INTERNAL MEMORANDUM

SUBJECT: P/25/0264 | Non material amendment to application P/25/0151 to include biodiversity enhancements required by condition 3 and to vary wording of conditions 4, 6 & 8 to change the timings for submission of information. | Y Goedwig Cardiff Road Treharris CF46 5NB

Figure 1 – build in bat and bird boxes

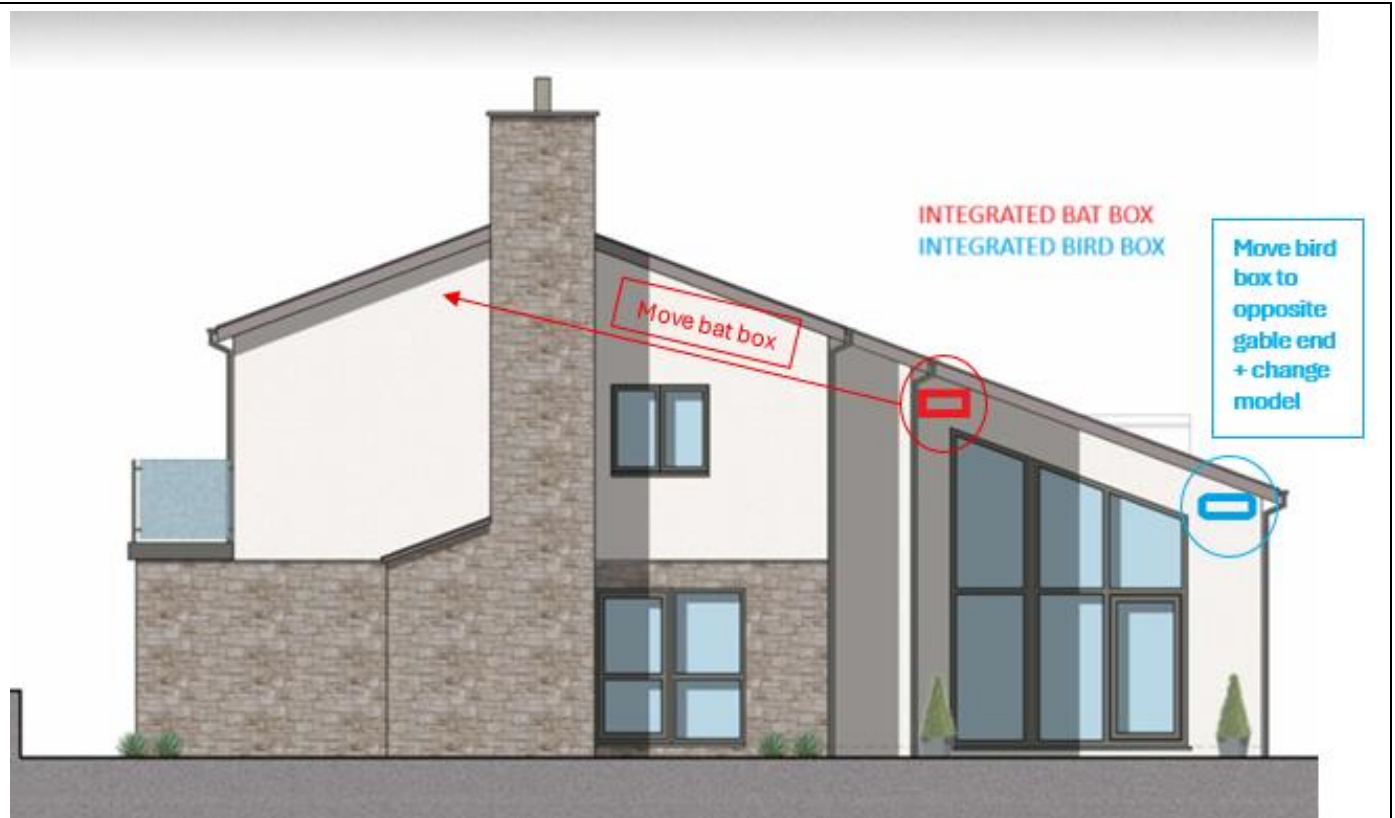
Both the bat and the bird box are *still* shown on the West South-West (WSW) elevation. Bird boxes must be positioned facing approximately north or east.

Therefore, please move the bird box to the East North-East (ENE) gable end.

The bat box specification as detailed in the submitted e-mail (#2 in the above list) is acceptable, but it should be moved to the position shown in Figure 1 (higher up and away from the windows):

The bird box specification as detailed in the submitted e-mail (#2 in the above list) is a box designed for swifts and therefore must be erected at least 5m from the ground and have clear flight lines to the front. An alternative might be the following:

To re-iterate, this should be integrated into the ENE gable end.
